# ADDENDUM 1

PROJECT NAME: MEDICAL CENTER INTERSECTION IMPROVEMENTS – PHASE X

DATE: 08/16/17

PROJECT NO.: **40-00309A**

**MEDICAL CENTER**  
**LOUIS PASTEUR AT EWING HALSELL**  
**WATER IMPROVEMENTS**  
**GENERAL NOTES AND QUANTITIES**

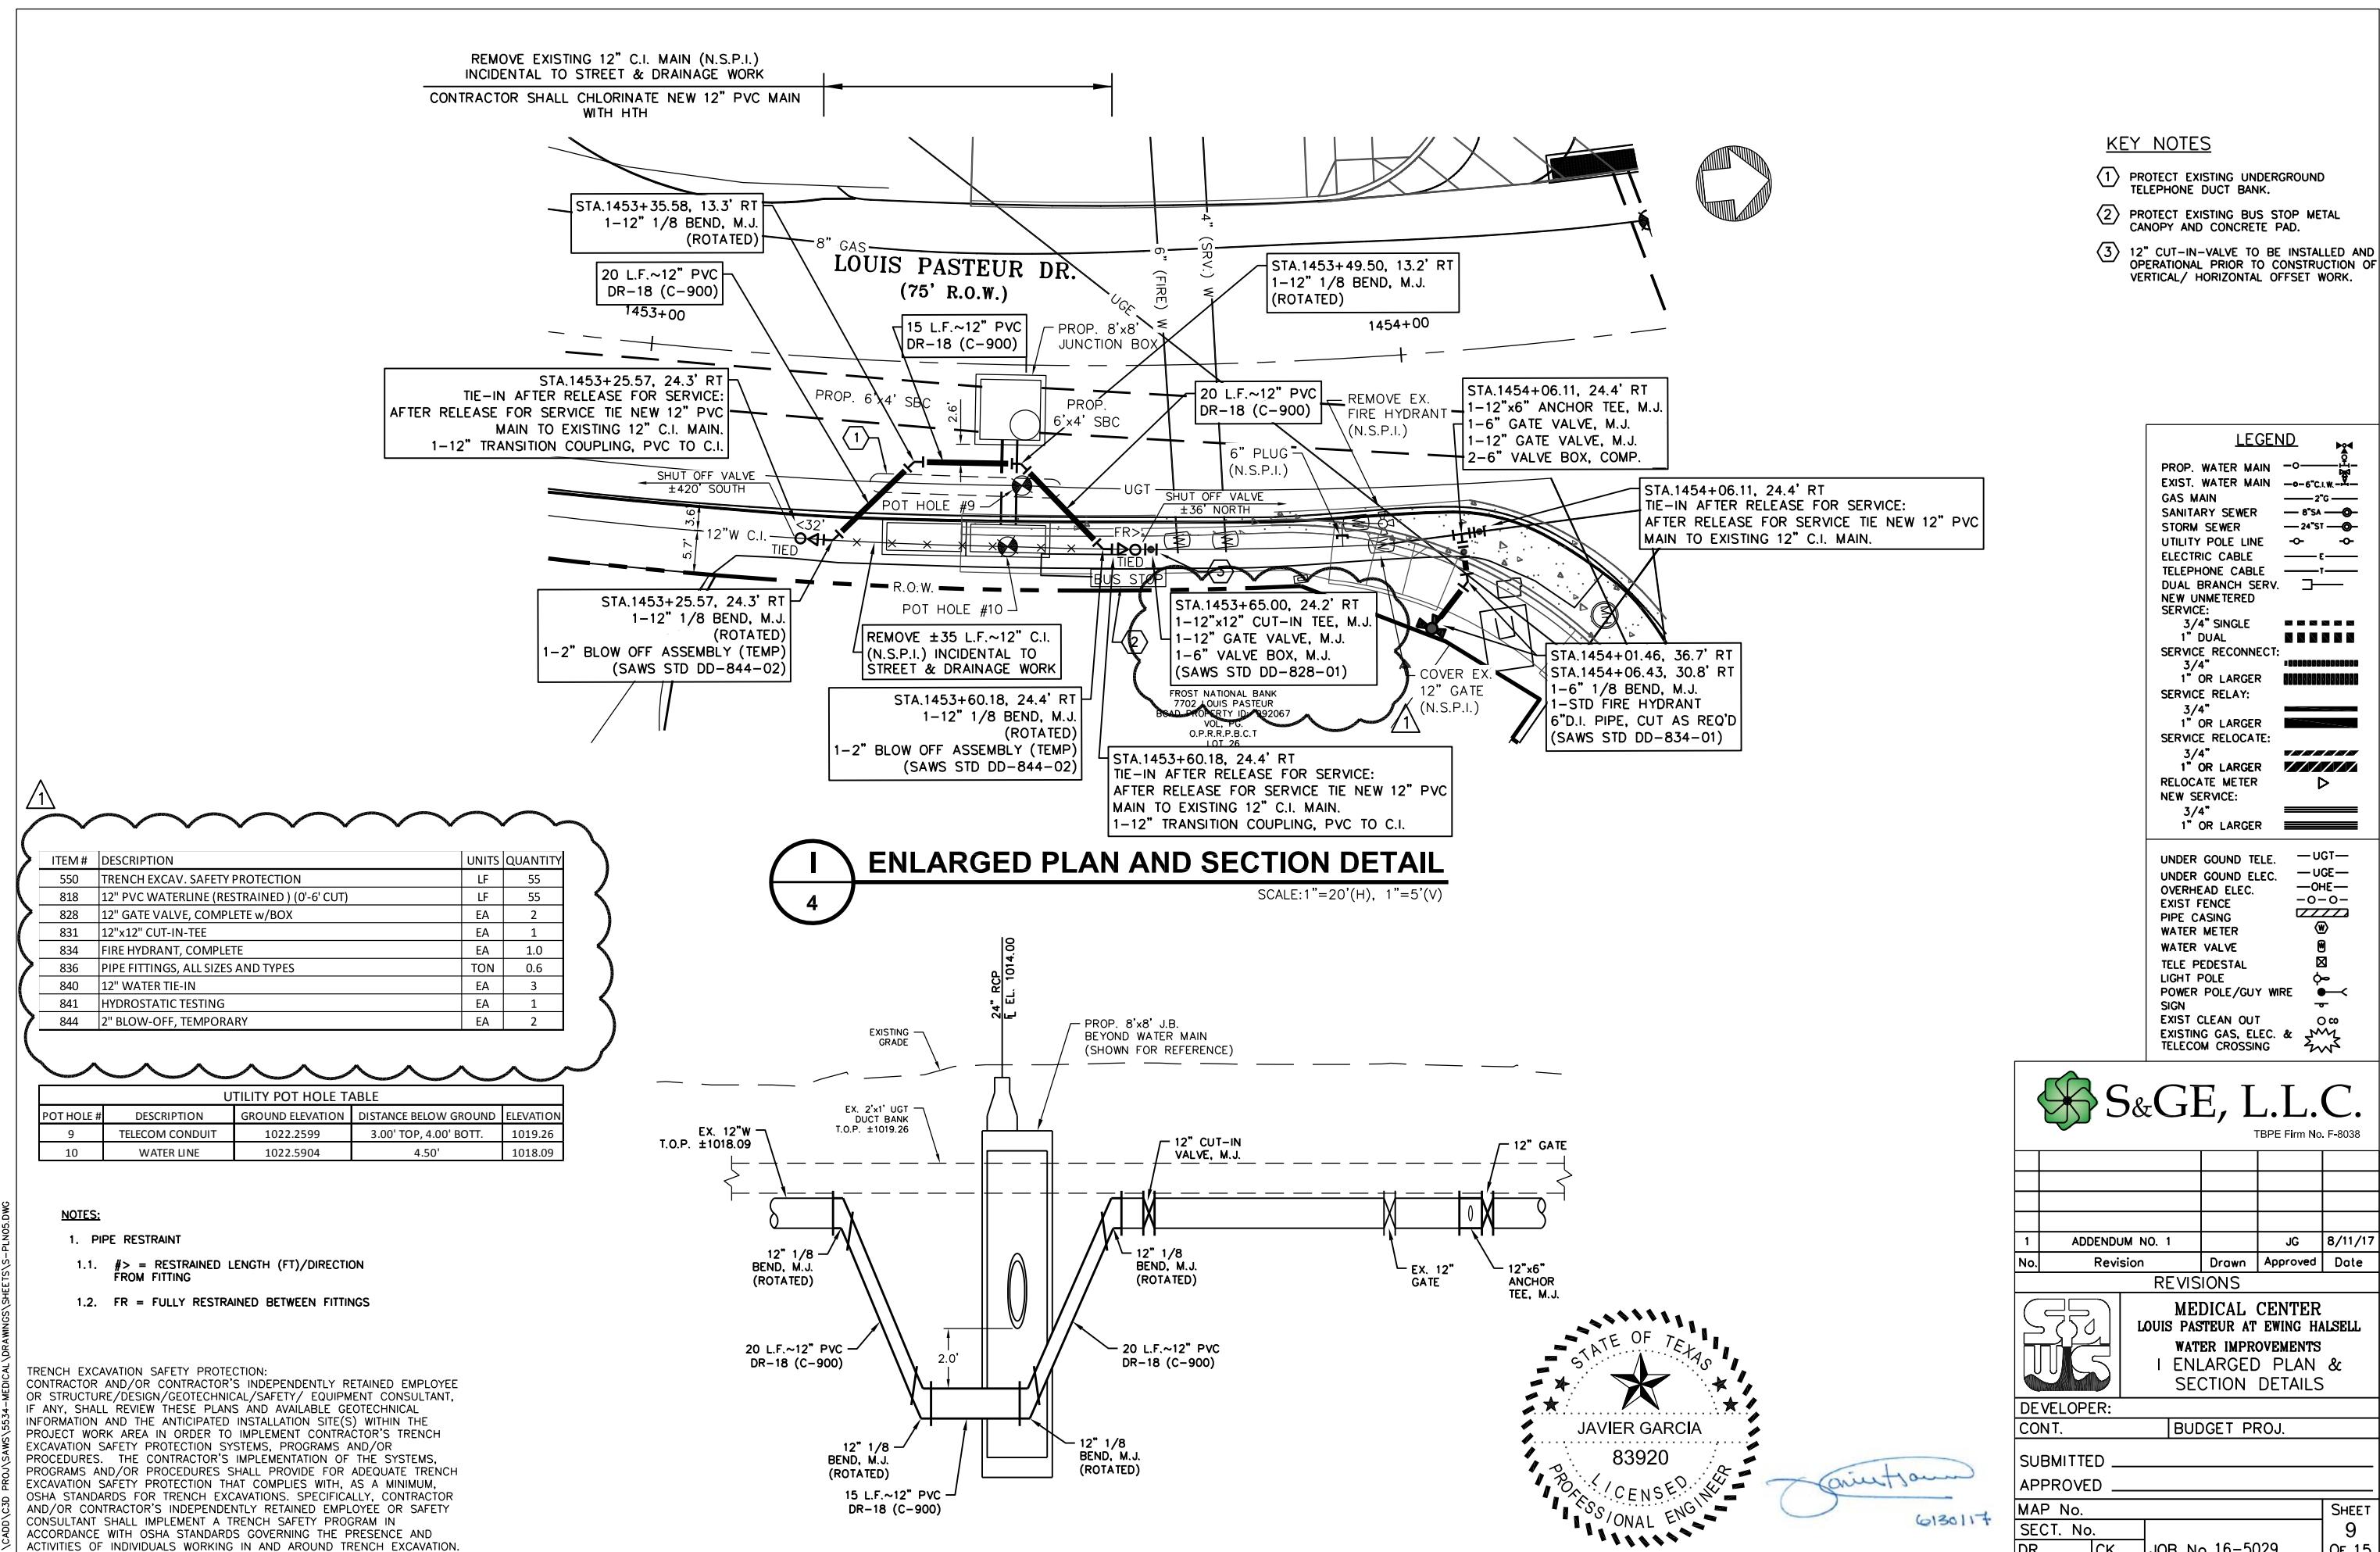
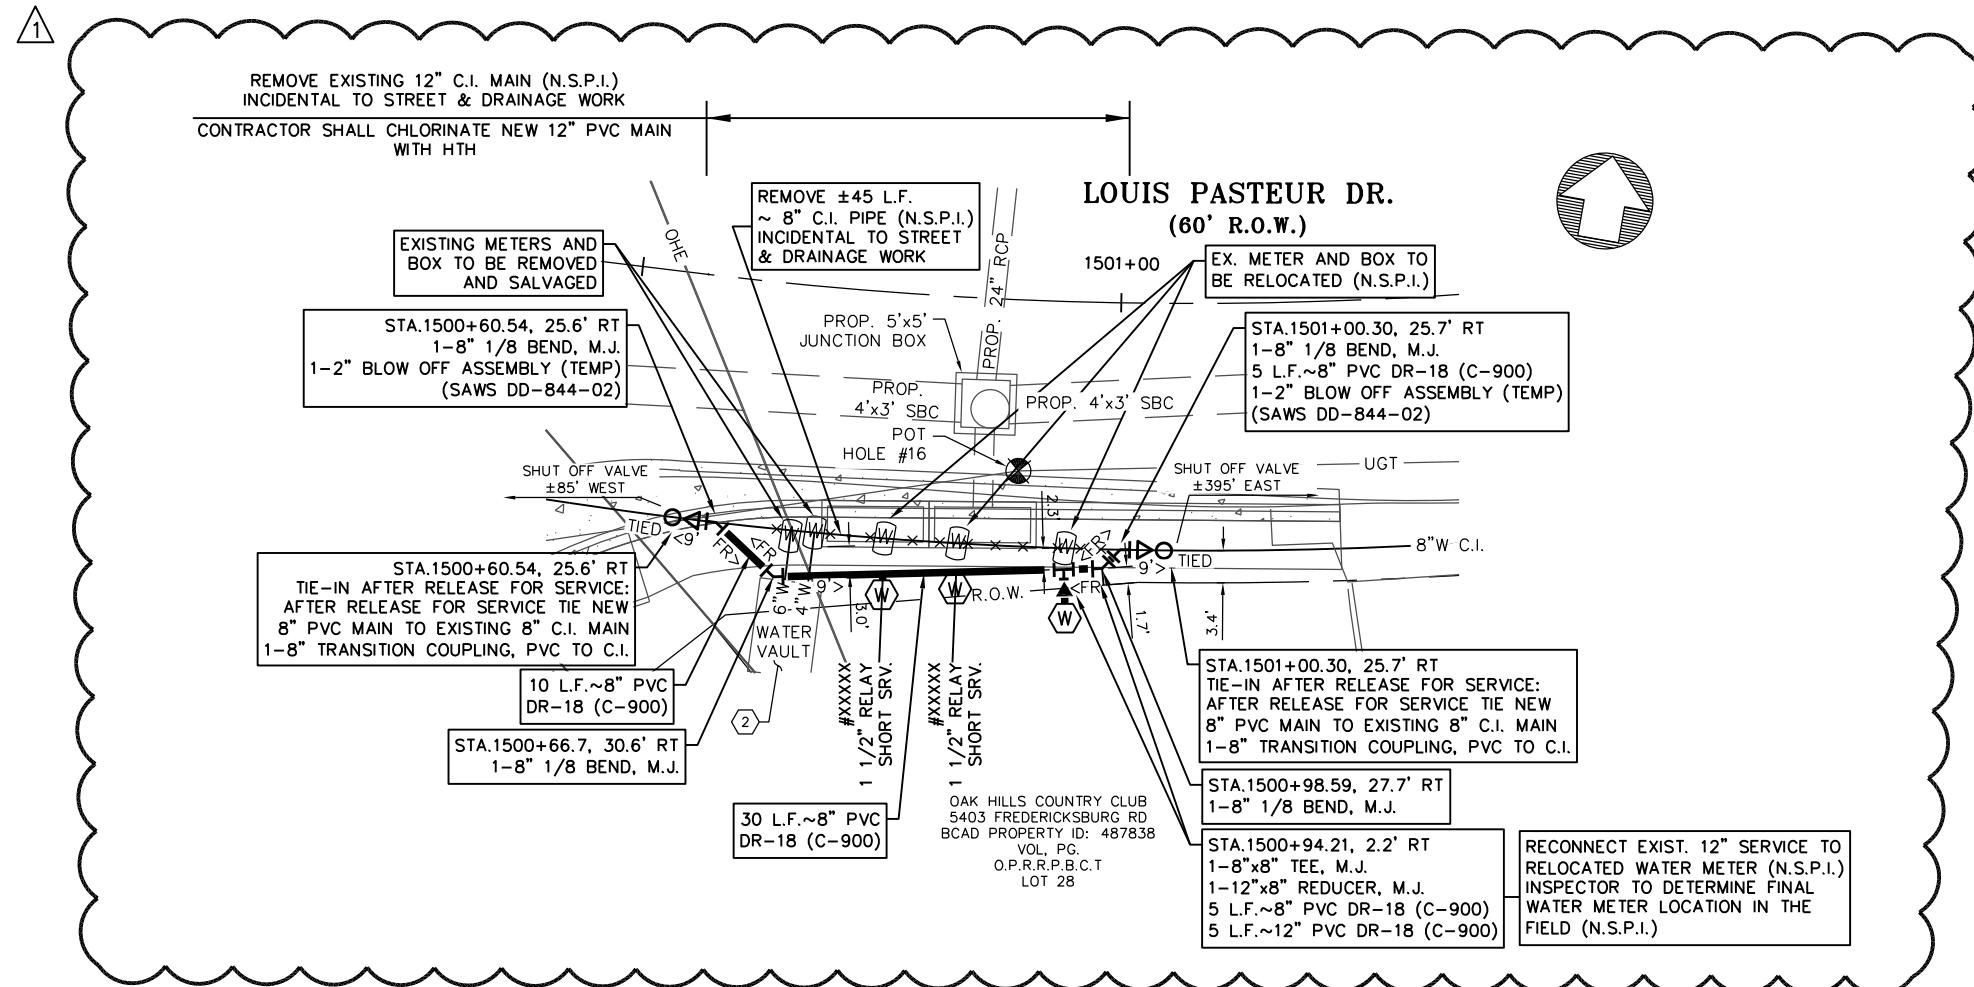
- Replace Sheet 2 of 15 “General Notes and Quantities” with Addendum 01 “General Notes and Quantities”.
  - Updated summary of water quantities table
- Replace Sheet 9 of 15 “Enlarged Plan and Section Detail” with Addendum 01 “Enlarged Plan and Section Detail”.
  - Updated table of quantities
- Replace Sheet 12 of 15 “Enlarged Plan and Section Detail” with Addendum 01 “Enlarged Plan and Section Detail”.
  - Updated table of quantities
  - Updated note about service connection.

MEDICAL CENTER  
LOUIS PASTEUR AT EWING HALSELL  
SEWER IMPROVEMENTS  
GENERAL NOTES AND QUANTITIES

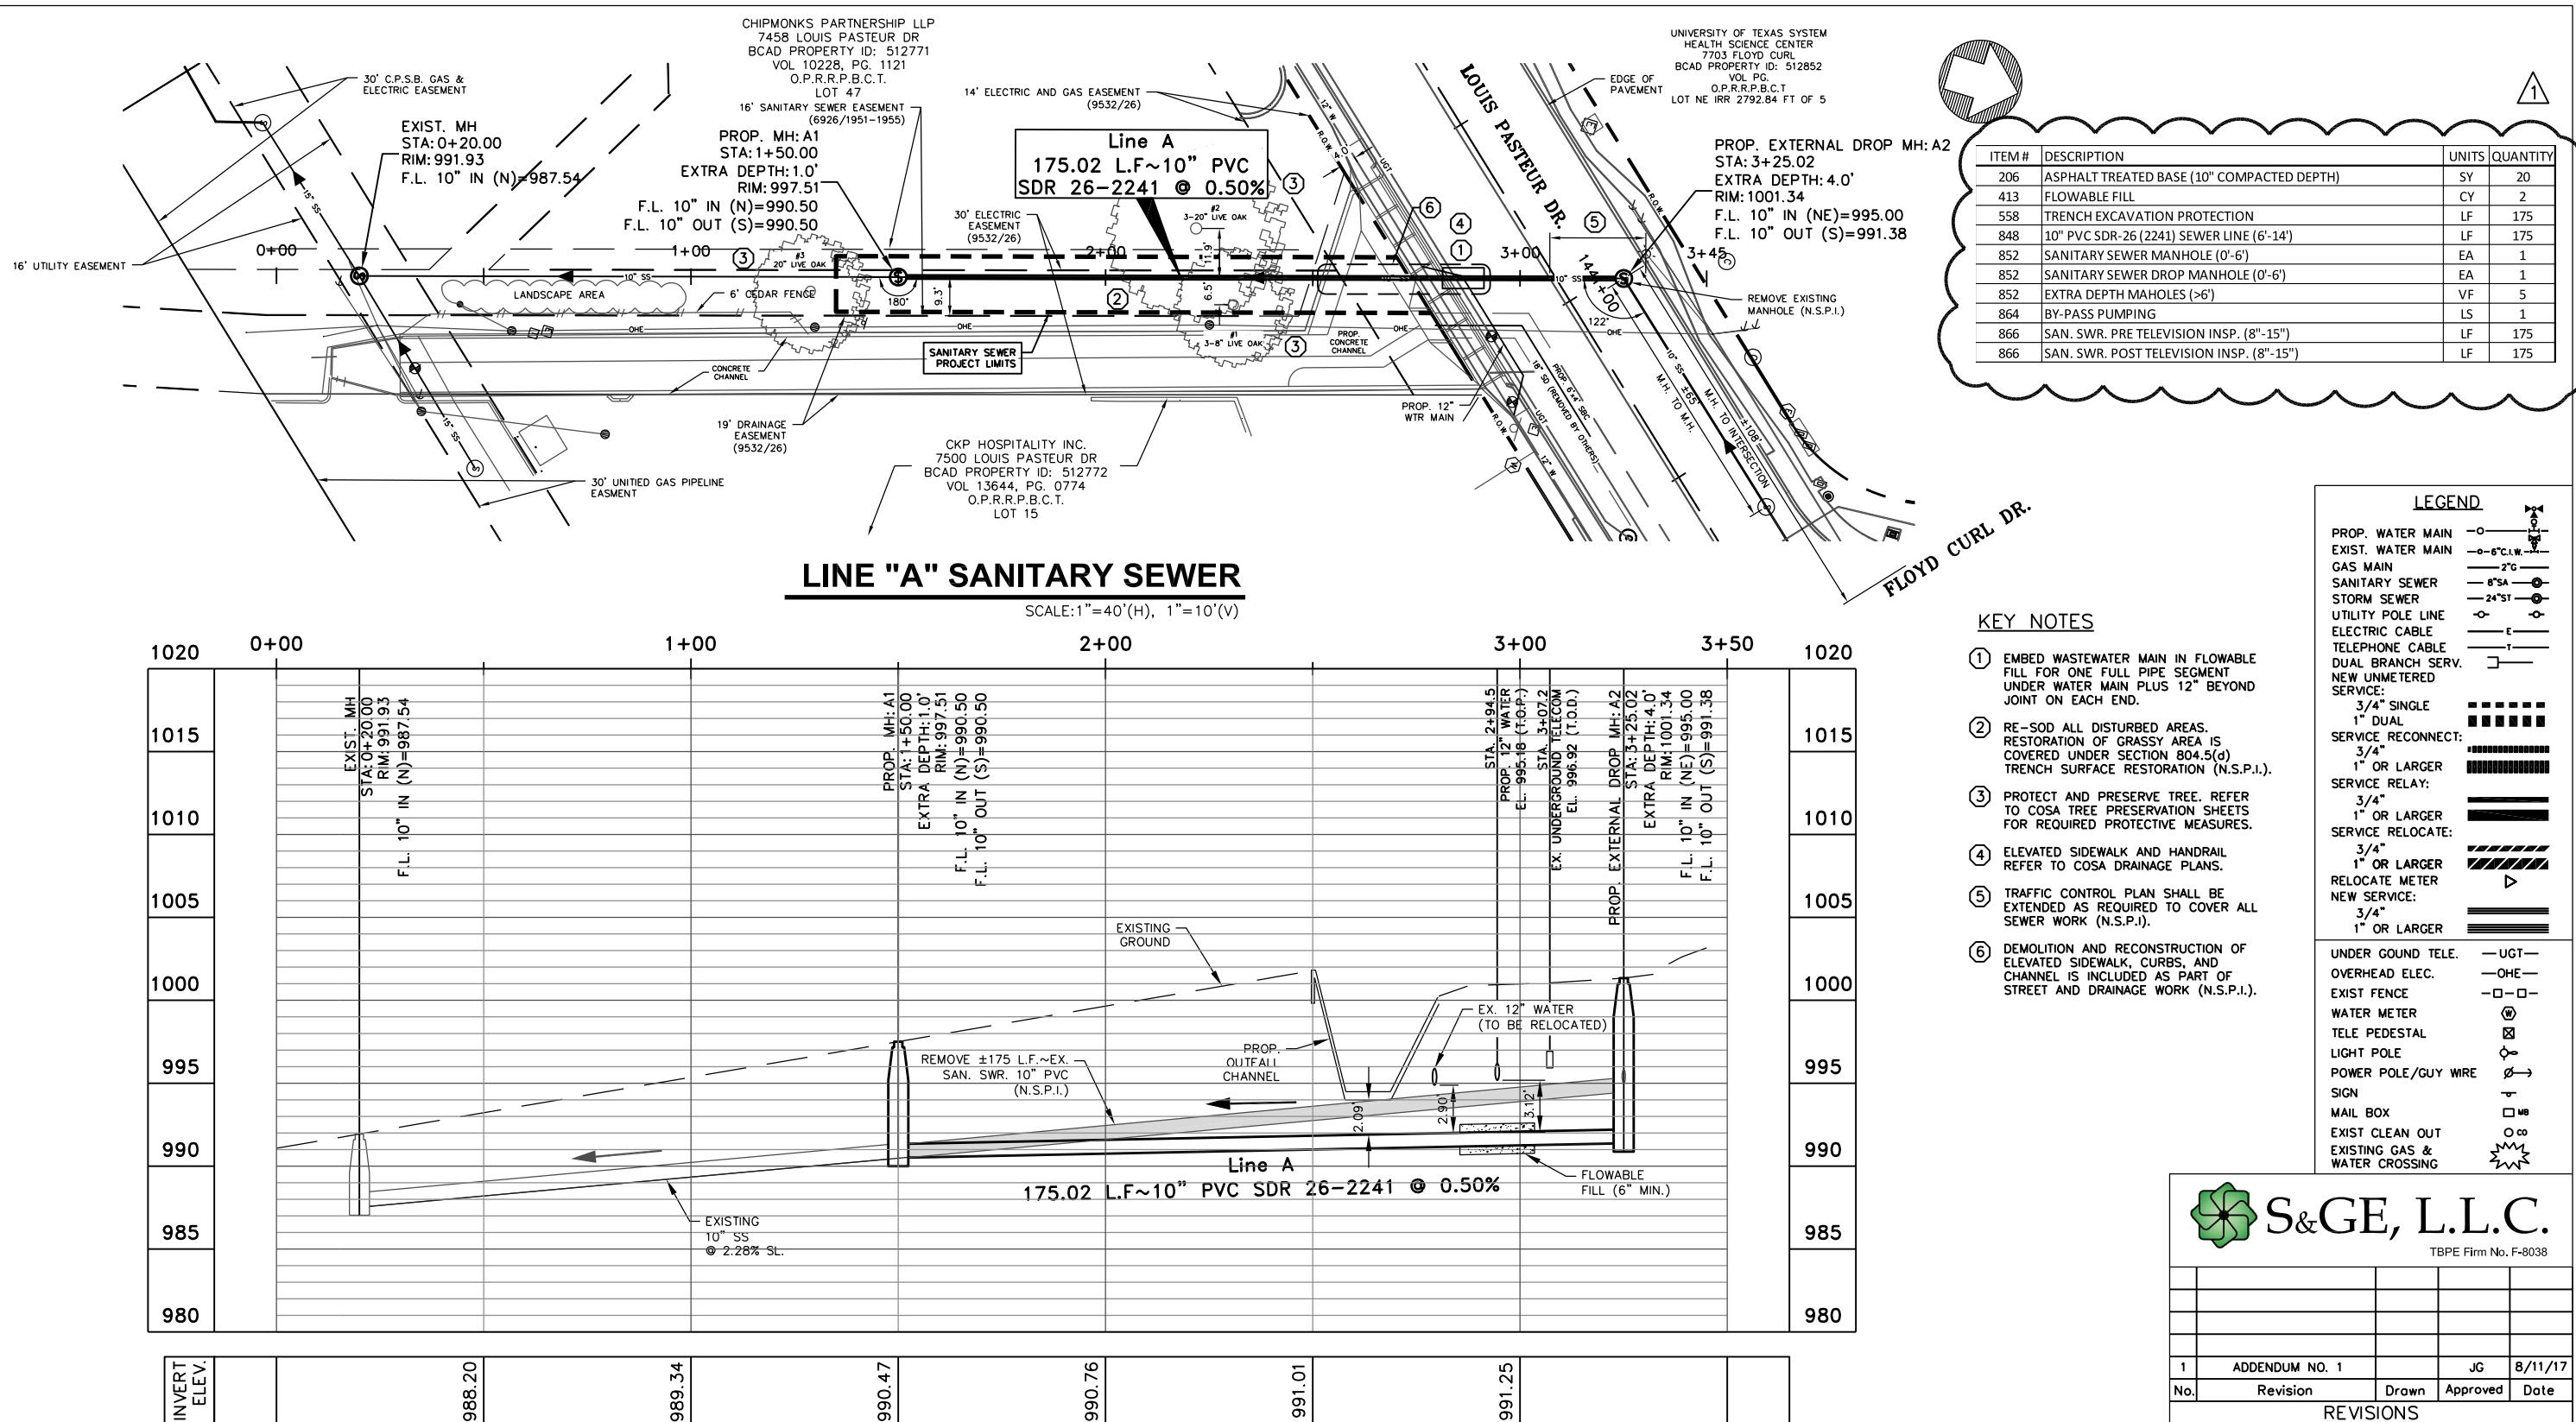
- Replace Sheet 2 of 5 “General Notes and Quantities” with Addendum 01 “General Notes and Quantities”.
  - Updated summary of sanitary sewer quantities.
- Replace Sheet 4 of 5 “Plan and Profile” with Addendum 01 “Plan and Profile”.
  - Updated table of quantities.
